## FIELD SERVICE BULLETIN

FSB Number: LVCCFSB2004-249  
Author: Ross Karlen  
Date: December 10, 2004  
Total No. of Pages: 5  
Subject: **3G V980 – No / Intermittent CLI Display**  
Model Affected: 3G V980's  
Level of Repair: 3

**Step 1: CLI board as assembled (For Disassembly of Flip, view Level 2 Service Manual posted on the WEB)**

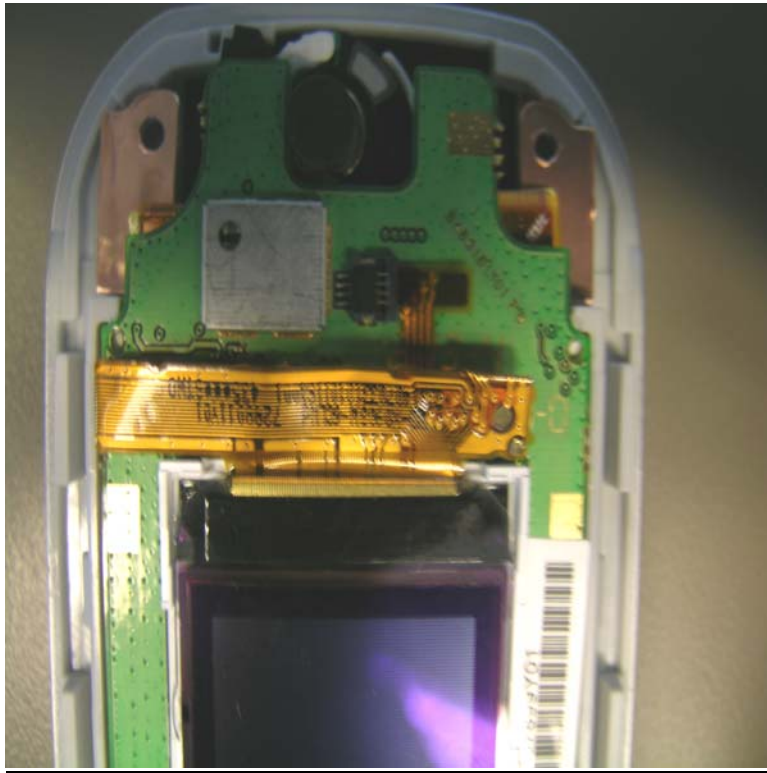
Service is aware of an issue, highlighted by Development. Some units were returned with a customer complaint of “No CLI Display or Intermittent CLI Display” during OOB inspection. Analysis revealed the CLI Flex component shorting to the PCBA copper etched date code to cause CLI failures.

Short Term Solution: Follow the following procedure of adding Kapton Tape on the PCBA.

Use Kapton tape as insulator  
Dimension of tape: approx 19 mm x 5.5 mm  
Location: over the current P/N (see slide 5)  
Color of tape: Optional
